Project	IEEE 802.16 Broadband Wireless Access Working Group < http://ieee802.org/16 >	
Title	Fast Anchor BS Switching Feedback Report Mechanism and Sleep Mode Support for SHO and FBSS	
Date Submitted	2004-08-31	
Source(s)	Jungwon Kim, Myung-Kwang Byun, Seung Joo Maeng, Jaeho Jeon, Jaeweon Cho, Changhoi Koo	jaeweon.cho@samsung.com
	Samsung Electronics	mhfong@nortelnetworks.com
	Hang Zhang, Mo-Han Fong, Jianglei Ma, Peiyong Zhu, Wen Tong	
	Nortel Networks	itzikk@runcom.co.il
	Itzik Kitroser, Yigal Leiba, Yossi Segal, Zion Hadad	
	Runcom Technologies	
	Mary Chion, Jing Wang	mchion@ztesandiego.com
	ZTE	
	Min-Sung Kim	cyberk@kt.co.kr
	KT	
	Donnie Dongkie Lee	galahad@nate.com
	SK Telecom	
	Chulsik Yoon	csyoon@etri.re.kr
	ETRI	
Re:	IEEE P802.16e/D4-2004	
Abstract	In this contribution, the fast Anchor BS switching feedback mechanism and sleep mode support for SHO/FBSS are proposed. The revision is highlighted in 'green'

Purpose	Review and Adopt the suggested changes into P802.16e/D4	
Notice	This document has been prepared to assist IEEE 802.16. It is offered as a basis for discussion and is not binding on the contributing individual(s) or organization(s). The material in this document is

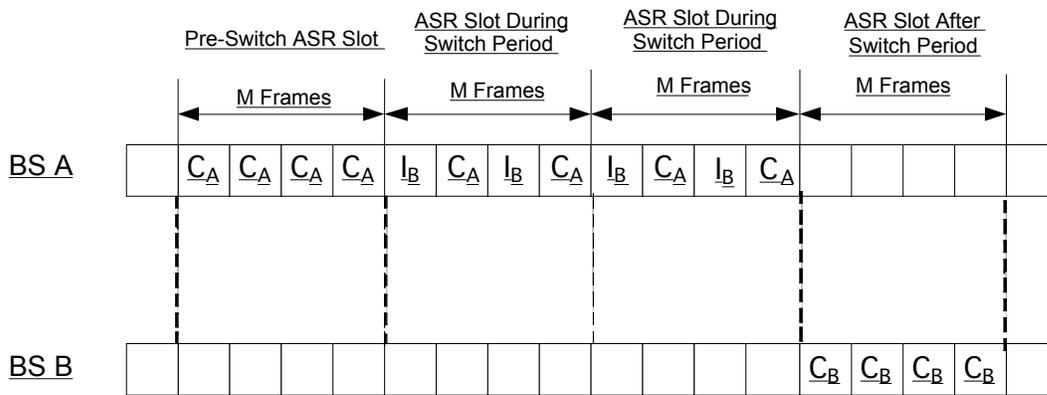
The following figure shows how the MSS requests the anchor switch. In the first ASR slot, the MSS detects the channel from BS B is better than BS A. However, for the purpose of synchronization, the MSS postpones the transmission of anchor BS switch indicator until the beginning of the next ASR slot.

At the start of the second ASR slot, the MSS shall start a switching timer with value equals to the switching period. Starting from the second ASR slot and for the subsequent ASR slots prior to the expiry of the switching timer, the MSS shall transmit the anchor switch indicator through CQICH allocated by the current Anchor BS (BS A) and the anchor BS may send the Anchor_Switch_IE prior to the expiry of the switching timer to do one of the following: 1) acknowledge the MSS' switch indication and/or assign a CQICH at the new Anchor BS (BS B), and/or specify a new action time when the switch shall occur, and/or specify a new anchor BS to switch to; 2) cancel the MSS switching event. If the MSS does not receive an Anchor_BS_switch_IE prior to the expiry of the switching timer, the MSS shall switch to the new Anchor BS after the expiry of the switching timer. If the MSS receives an Anchor_BS_Switch_IE prior to the expiry of the switching timer with no cancellation and no new action time specified, the MSS shall switch to the new Anchor BS after the expiry of the switching timer. If the MSS receives an Anchor_BS_Switch_IE prior to the expiry of the switching timer with new action time specified, the MSS shall switch to the new Anchor BS at the action time specified. If the MSS receives an Anchor_BS_Switch_IE with cancellation prior to the expiry of the switching timer, the MSS shall cancel the switching operation. If the MSS successfully decodes the Anchor_BS_Switch_IE, it shall confirm the reception of the IE using the allocated codeword over the CQICH. Prior to the expiry of the switching timer, the MSS shall report CQI of BS A and anchor switch indication on alternate frames. Prior to the expiry of the switching timer, if the MSS has intention to cancel the switching due to factor such as the signal strength of BS B is no longer higher than that of BS A by a certain threshold,

If no cancellation occurs, after the expiry of the switching timer, the MSS shall switch to BS B and monitor the downlink of BS B. If the BS B has already pre-allocated a CQICH to the MSS (this can be done using MOB-BSHO-RSP or Anchor_Switch_IE), the MSS reports the CQI using the allocated CQICH and may begin the normal communication with BS B starting from the first frame after the expiry of the switching timer. If CQICH is not pre-allocated to the MSS prior to the switch, the MSS shall monitor the MAP from BS B and waits for the CQICH allocation after the switch. If after the switch, the MSS does not receive a CQICH allocation within duration equals to the switching period, the MSS may start the HO network re-entry with BS B. The following figure shows an example where the switching timer is equals to 2 ASR slots.

Figure xx. Fast Anchor BS Selection mechanism

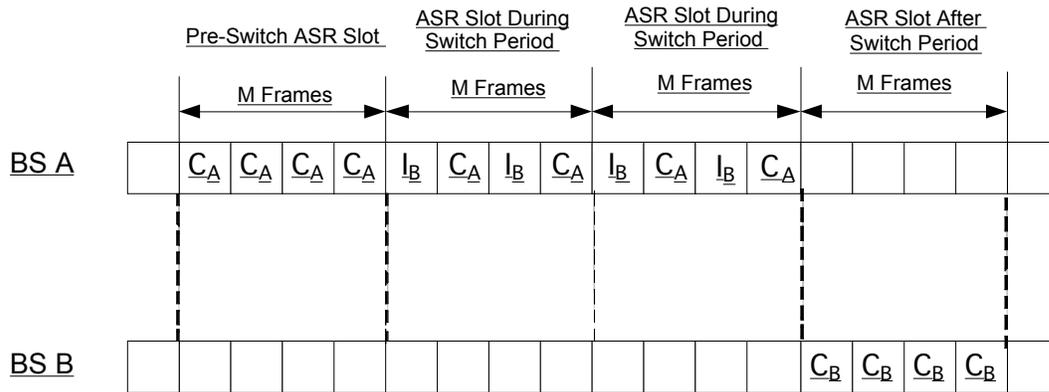
The switching operation for $L = 2$ is illustrated in figure xxx. In the first ASR slot, the MSS detects the signal strength from a BS in the active set (e.g. BS B) is better than that of the current anchor BS (e.g. BS A) such that a switch to the new anchor BS is desired. The MSS transmits the anchor BS switch indicator at the beginning of the next ASR slot. At the start of the second ASR slot, the MSS shall start a switching timer with value equals to the switching period. Starting from the second ASR slot and for the subsequent ASR slots prior to the expiry of the switching timer, the MSS shall transmit the anchor switch indicator through CQICH allocated by the current Anchor BS (e.g. BS A).

The current anchor BS may send the Anchor Switch IE prior to the expiry of the switching timer to do one of the following: 1) acknowledge the MSS' switch indication and/or assign a CQICH at the new Anchor BS (BS B), and/or specify a new action time when the switch shall occur, and/or specify a new anchor BS to switch to; 2) cancel the MSS switching event. If the MSS does not receive an Anchor_BS_switch_IE prior to the expiry of the switching timer, the MSS shall switch to the new Anchor BS after the expiry of the switching timer. If the MSS receives an Anchor_BS_Switch_IE prior to the expiry of the switching timer with no cancellation and no new action time specified, the MSS shall switch to the new Anchor BS after the expiry of the switching timer. If the MSS receives an Anchor_BS_Switch_IE prior to the expiry of the switching timer with new action time specified, the MSS shall switch to the new Anchor BS at the action time specified. If the MSS receives an Anchor_BS_Switch_IE with cancellation prior to the expiry of the switching timer, the MSS shall cancel the switching operation. If the MSS successfully decodes an Anchor_BS_Switch_IE, the MSS shall acknowledge the reception of the IE using the allocated codeword over the CQICH.

Prior to the expiry of the switching timer, the MSS shall report COI of the current anchor BS (e.g. BS A) and anchor switch indication on alternate frames. If the MSS started the switching operation by indicating a BS within the active set (e.g. BS B) as the new anchor BS, the MSS shall not indicate another new anchor BS prior to the expiry of the switching timer. Prior to the expiry of the switching timer, if the MSS has intention to cancel the switching due to factor such as the signal strength of the new anchor BS (e.g. BS B) is no longer higher than that of the current anchor BS (e.g. BS A) by a certain threshold, the MSS shall continue to indicate BS B in the CQICH during the switching period. However, the MSS can initiate the cancellation of the anchor BS switch by the following way, if and only if no Anchor_BS_Switch_IE with cancellation flag disabled is received prior to the expiry of the switching timer. In such case, after the expiry of the switching timer, the MSS shall stay with BS A and shall transmit the COI on the same CQICH allocated by BS A in the same fashion as prior to the switch operation starts, the codeword indicating BS A at the first frame in the next ASR slot to let the original anchor BS (e.g. BS A) know that it cancels the anchor switch. In addition, the original anchor BS (e.g. BS A) shall check if the MSS stays with BS A to cancel the anchor switch at the next ASR slot. On the BS side, after the expiry of the switching timer, the BS A shall continue to monitor the same CQICH allocated to the MSS for an implementation dependent duration. If COI transmission is detected, the BS A shall assume that the MSS has cancelled the switch. The MSS shall not initiate cancellation of the switch if Anchor_BS_Switch_IE with cancellation flag disabled is received prior to the expiry of the switching timer.

If no cancellation occurs, after the expiry of the switching timer, the MSS shall switch to the new anchor BS (e.g. BS B) and monitor the downlink of BS B. If the BS B has already pre-allocated a CQICH to the MSS (this can be done using MOB-BSHO-RSP or Anchor_Switch_IE), the MSS reports the COI using the allocated CQICH and may begin the normal communication with the new anchor BS (e.g. BS B) starting from the first frame after the expiry of the switching timer. If CQICH is not pre-allocated to the MSS prior to the switch, the MSS shall monitor the MAP from the new anchor BS (e.g. BS B) and waits for the CQICH allocation after the switch. If after the switch, the MSS does not receive a CQICH allocation within duration equals to the switching period, the MSS may start the HO network re-entry with the new anchor BS (e.g. BS B).
